INDIANA DEPARTMENT OF TRANSPORTATION

STANDARDS COMMITTEE MEETING

REVISED AGENDA

November 19, 2009 Standards Committee Meeting

REVISION TO THE STANDARD DRAWINGS
 701-BPIL-04 SPLICING PIPE PILES IN FIELD
 (PROPOSED STANDARD DRAWING REVISION)

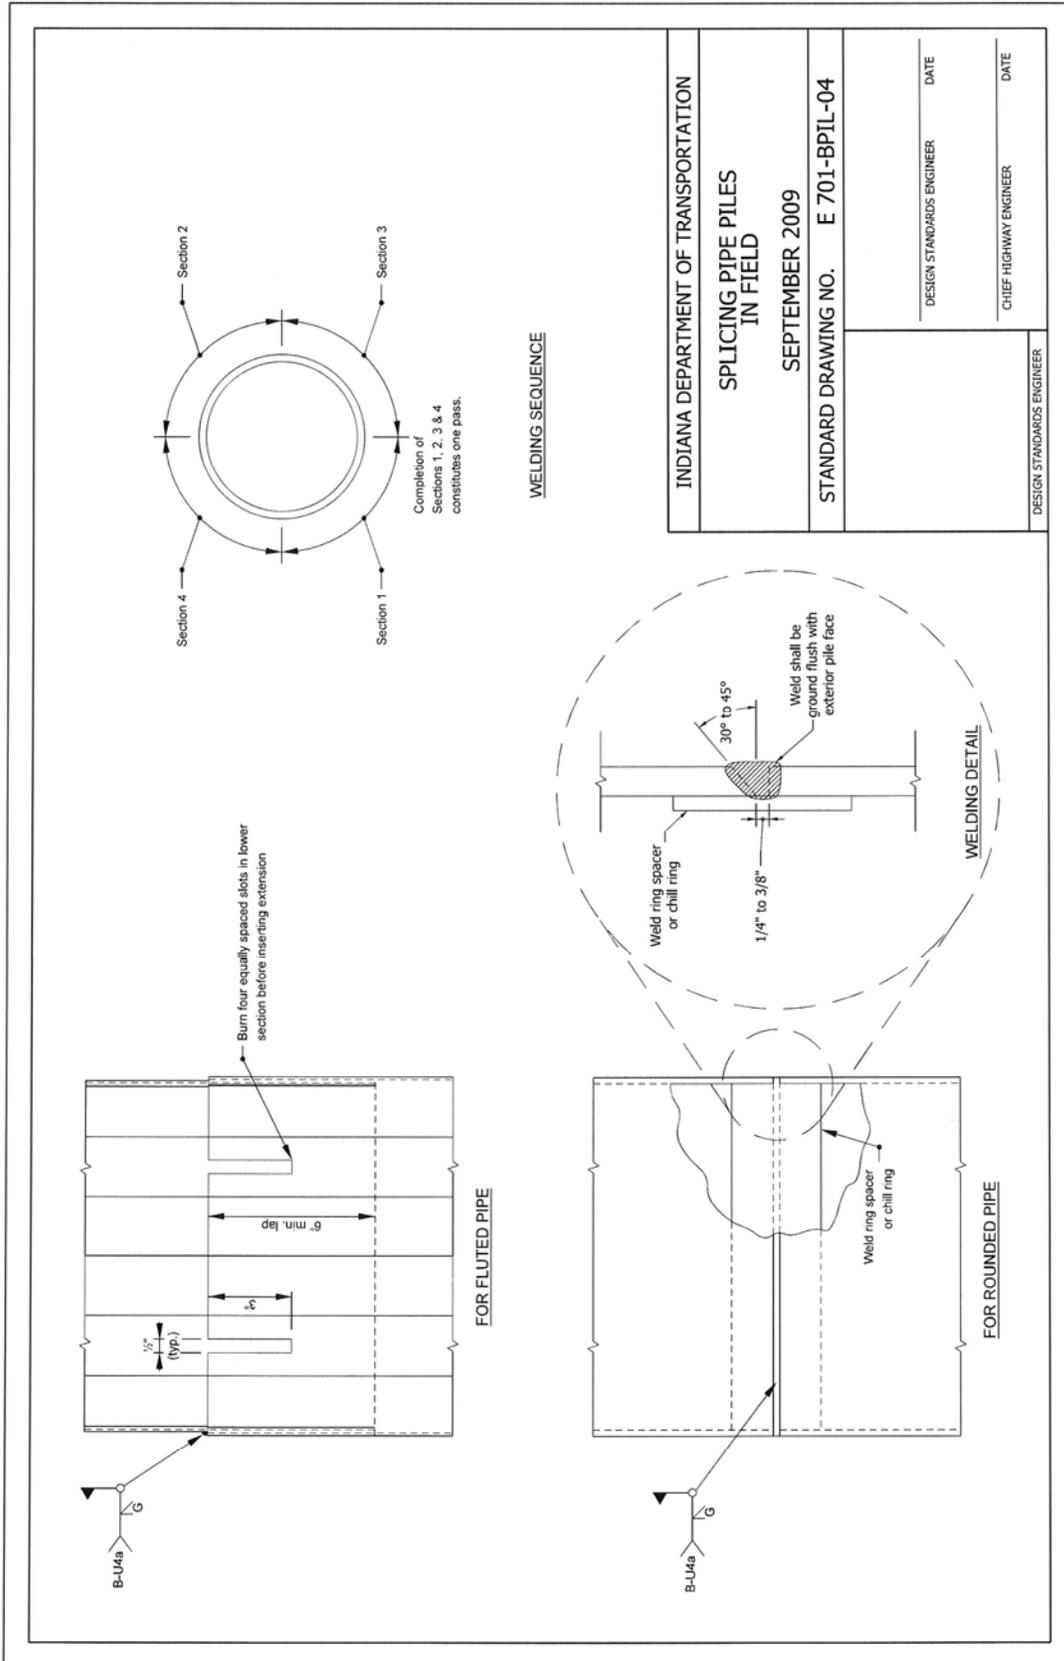
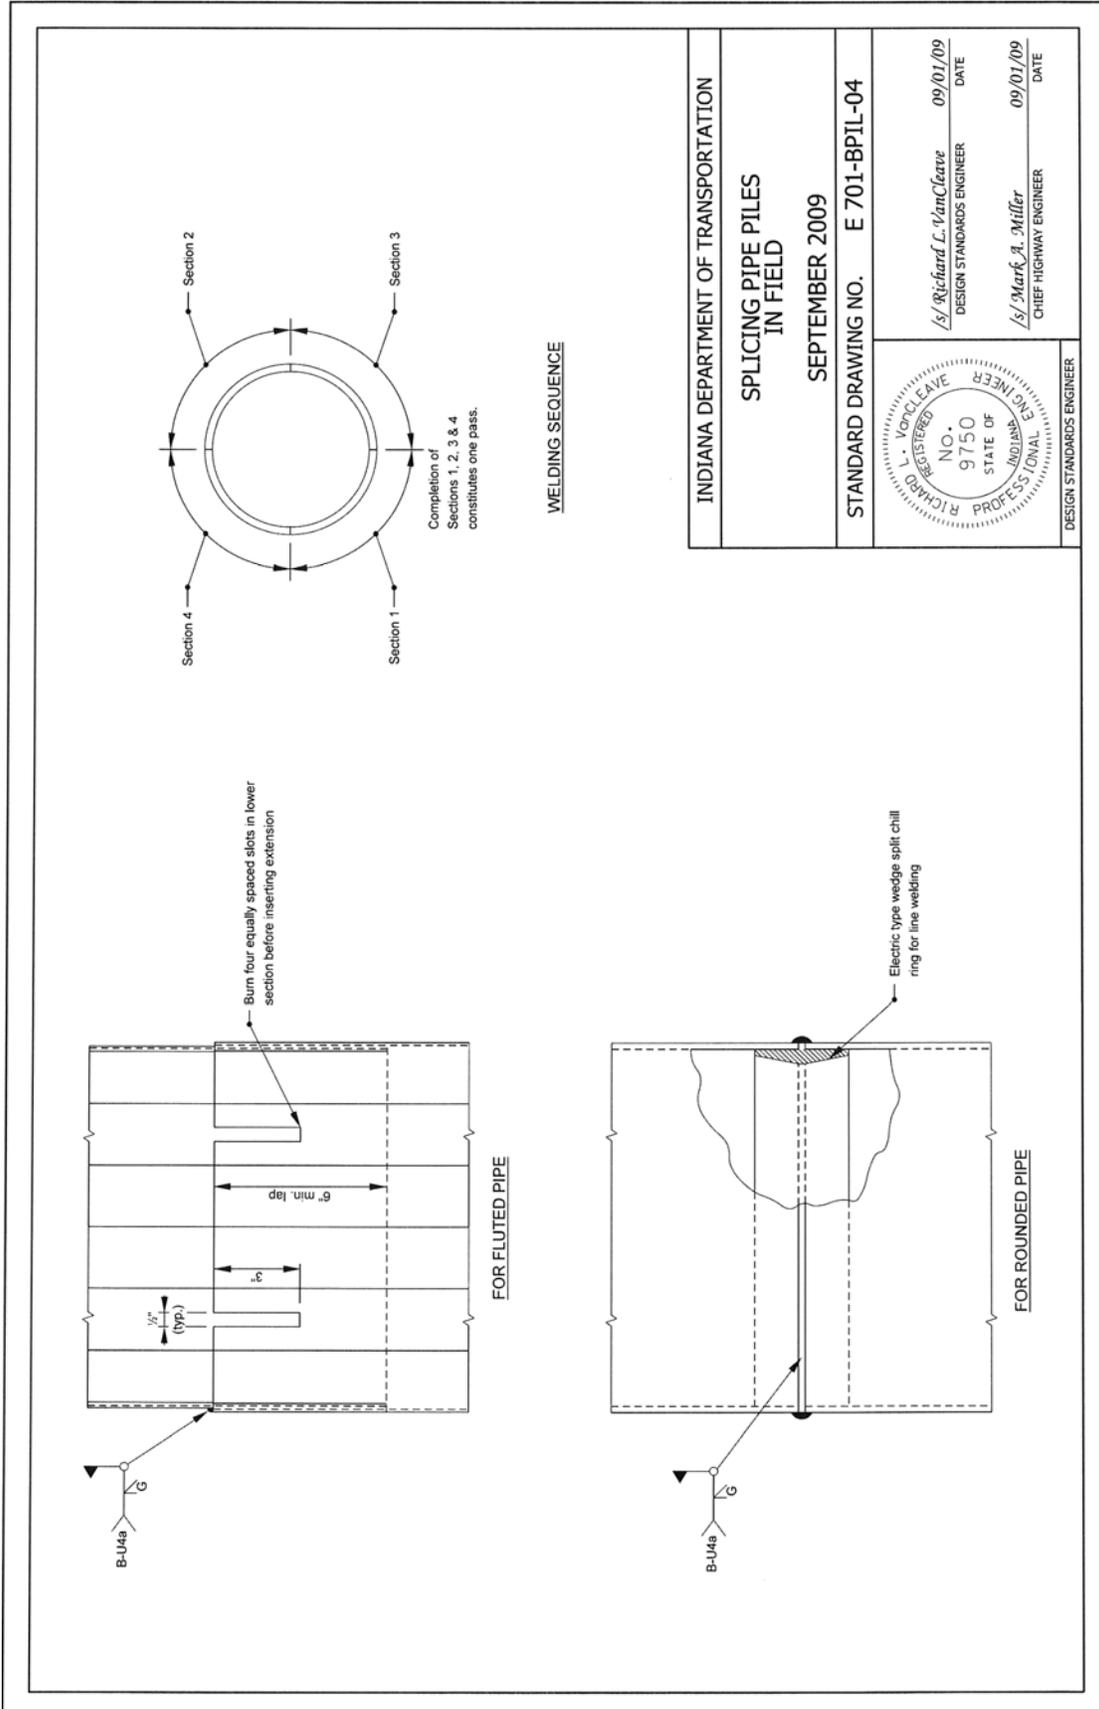
PROBLEM(S) ENCOUNTERED: The weld detail information on standard drawing 701-BPIL-04 is not clear. It is widely reported that the beveled edge is not being placed on the piling, nor is the gap being provided prior to welding. The lack of a beveled edge or gap between the piles may be a cause of recent welded splice failures.

PROPOSED SOLUTION: Add a "blown up" detail of the weld area showing the beveled edge on the upper pipe pile and the space that is supposed to be between the piles being spliced. Incorporating this detail on the Standard Drawing will help clarify the weld detail to the PE/S since very few individuals have knowledge of or access to the AWS Bridge Welding Code to know what the B-U4a weld symbol shown on the current drawing indicates or requires.
